DATE: **May 23, 2025**

PROJECT NAME: **LXT General Aviation Terminal  
Lee's Summit City Project #17932172**

ADDENDUM No. **1**

A-602

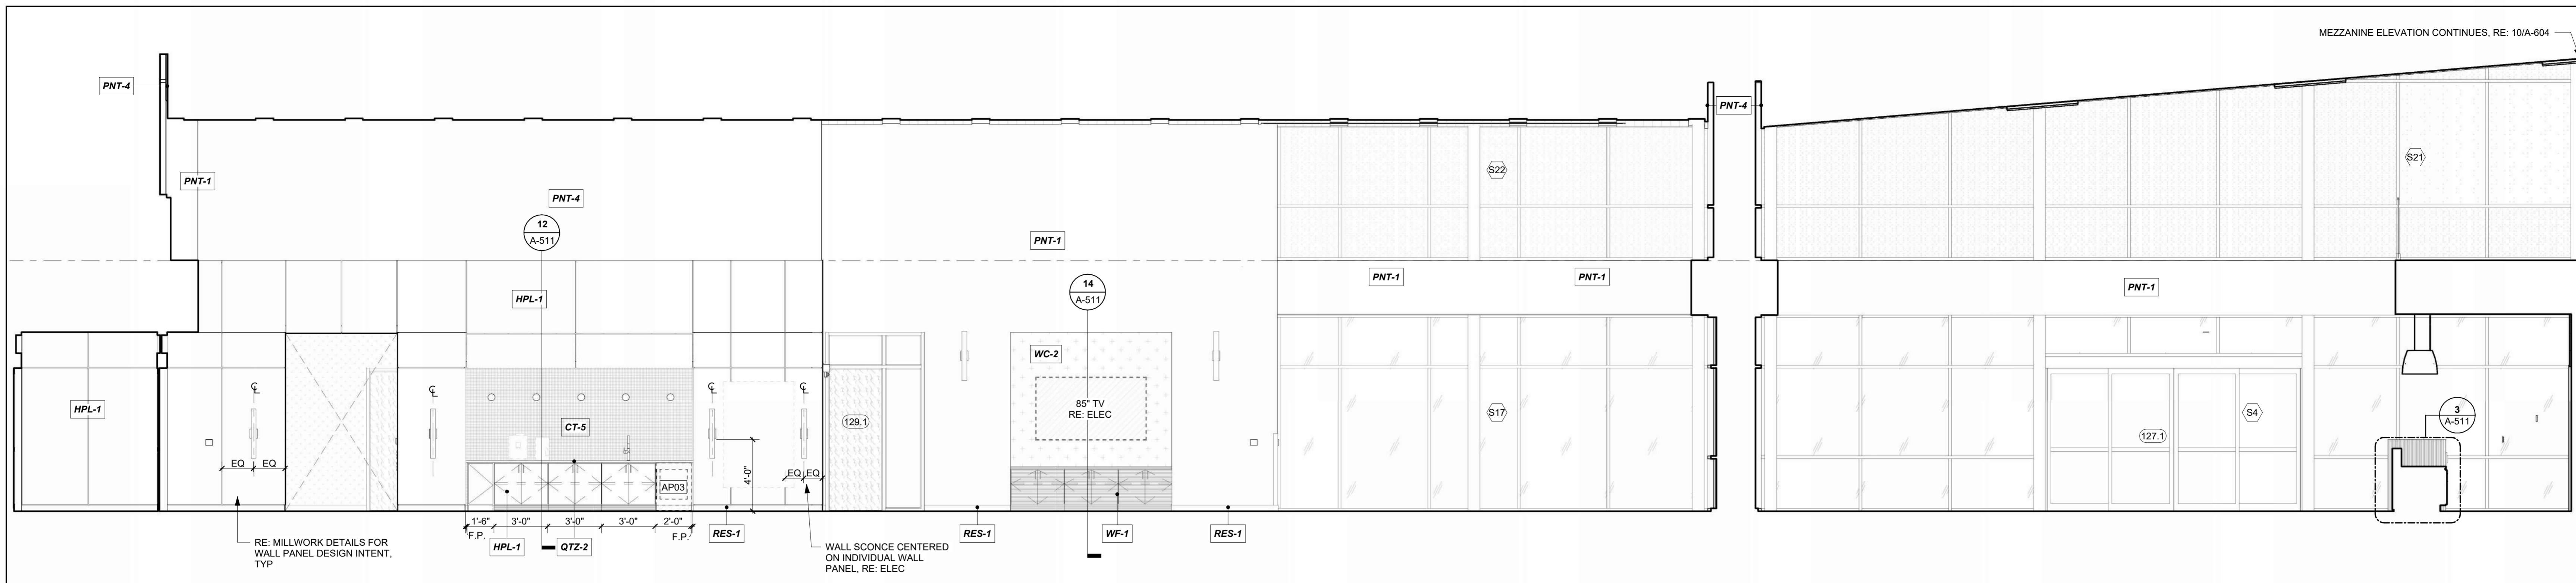
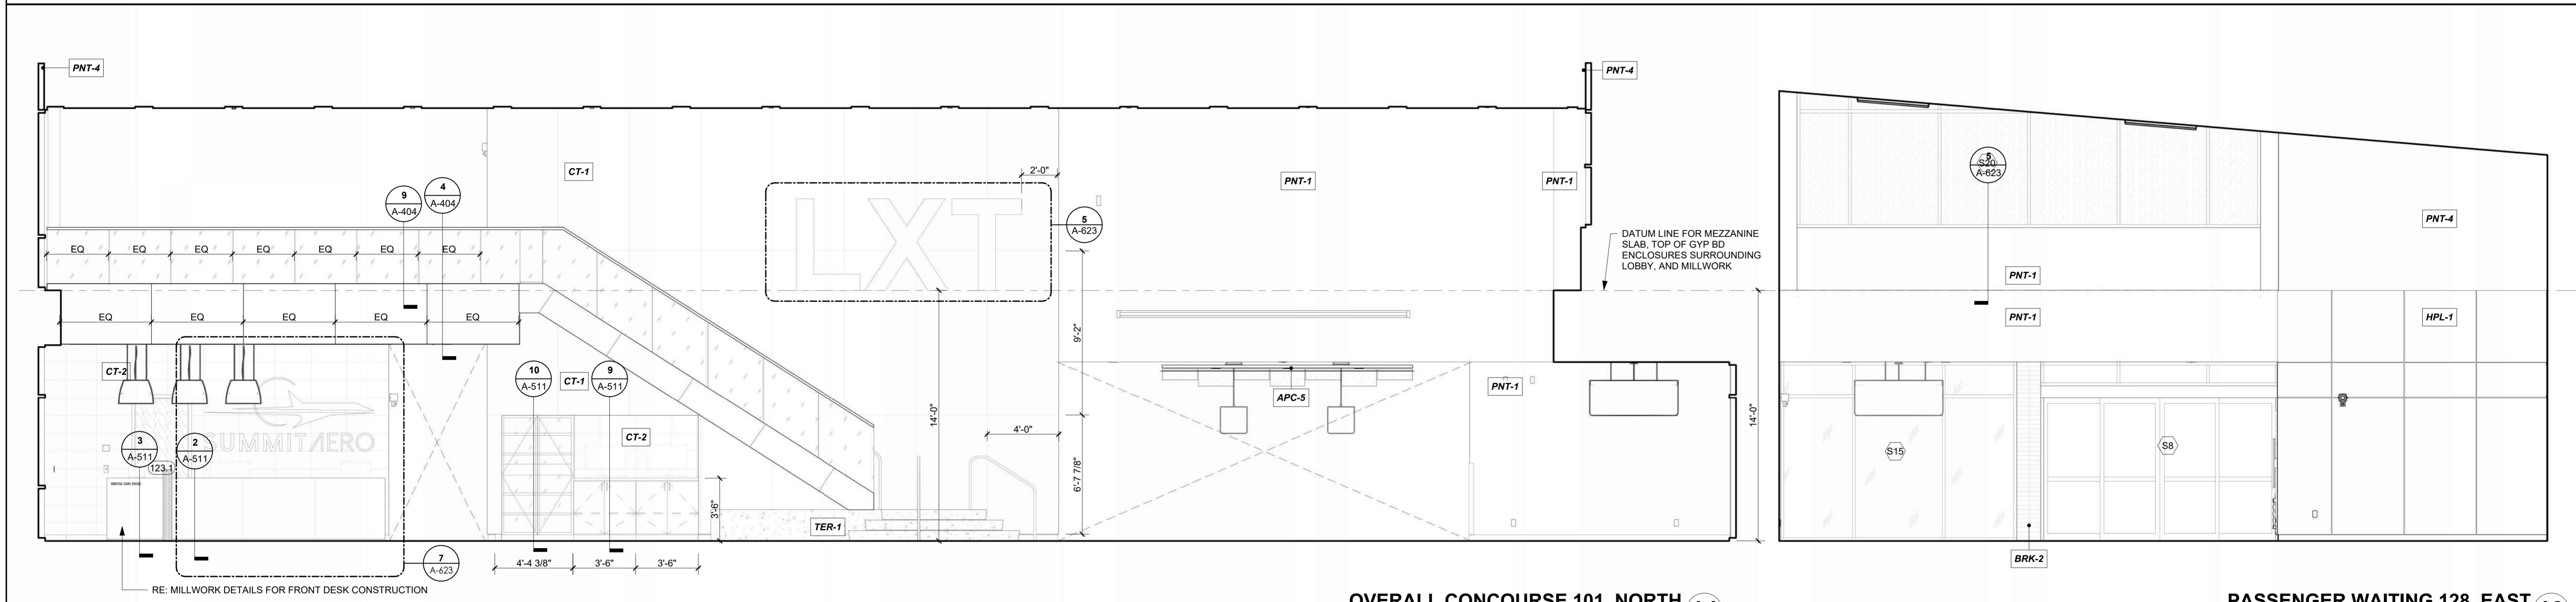
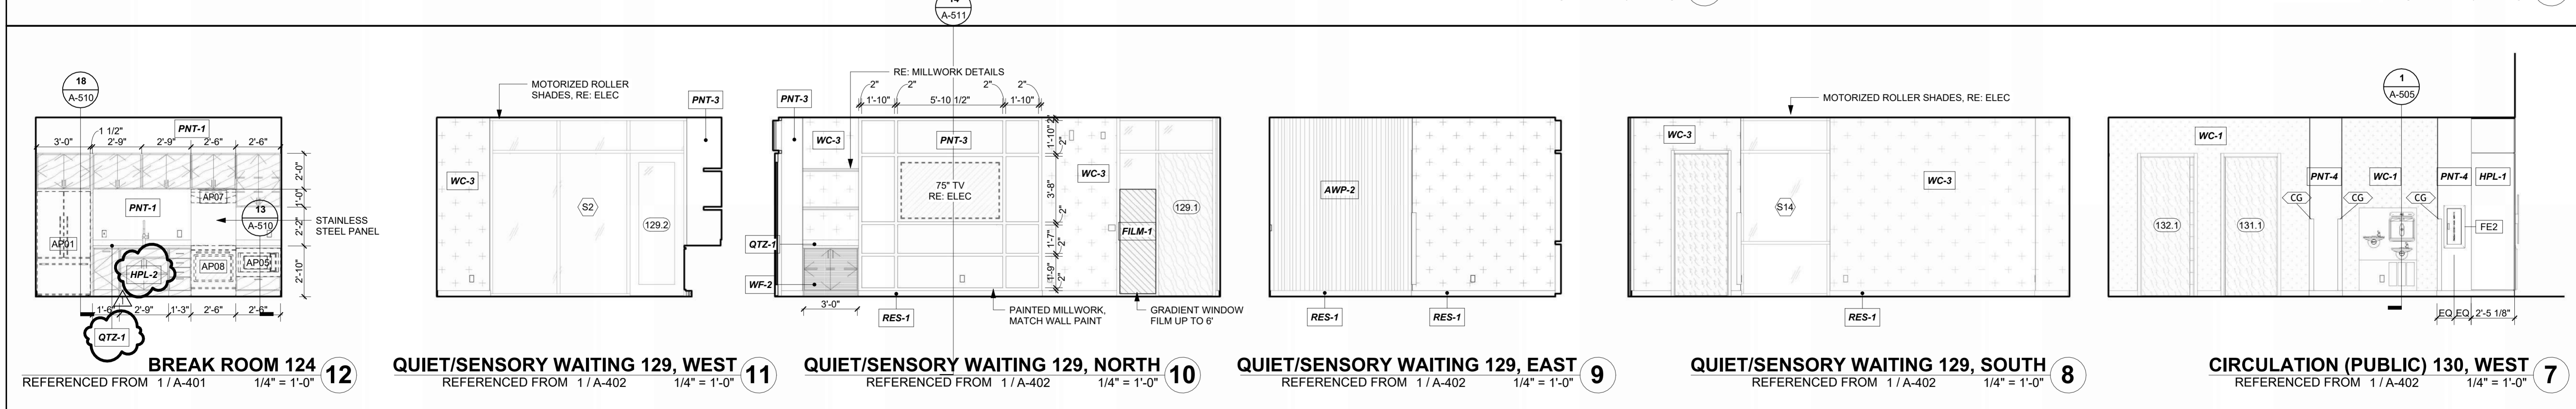
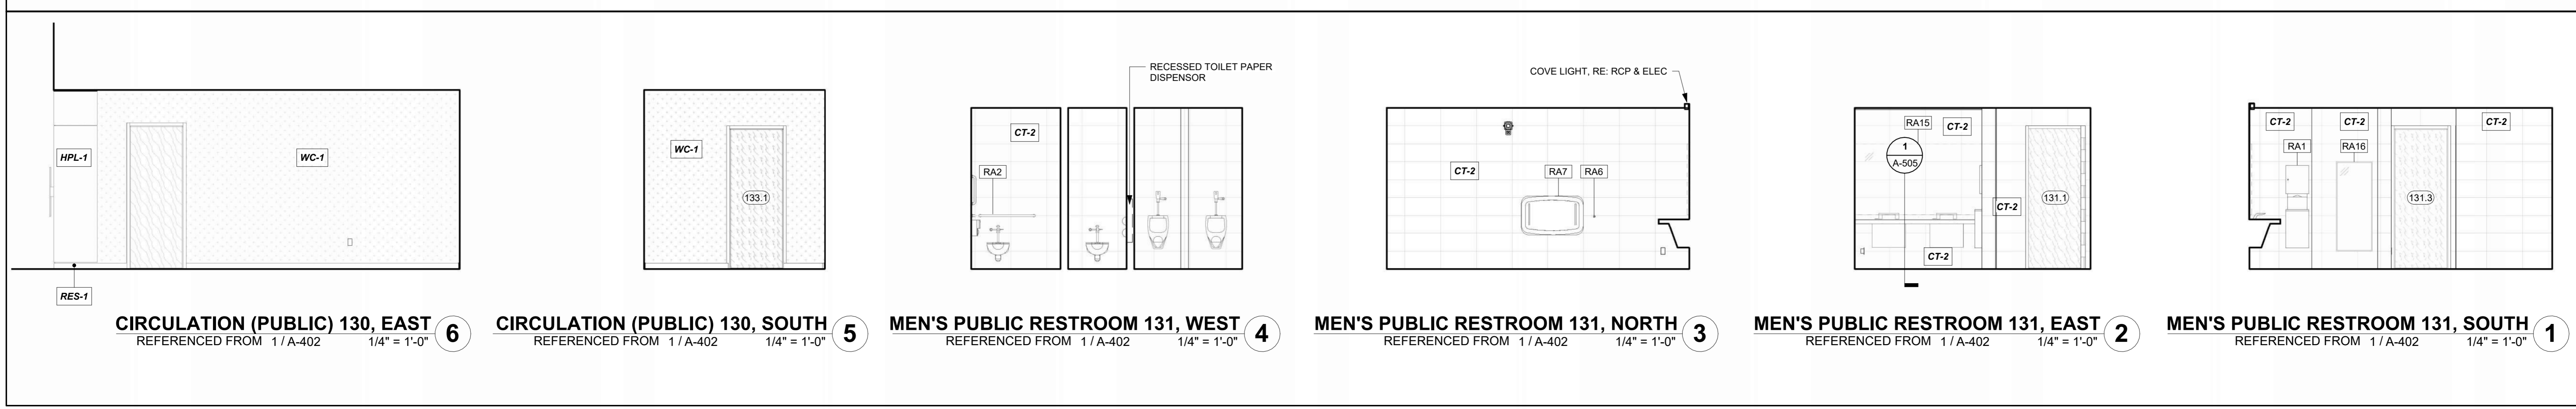
- a. **REVISE** to include "FLAT CUT VENEER, CLEAR FINISH" to WF-2.
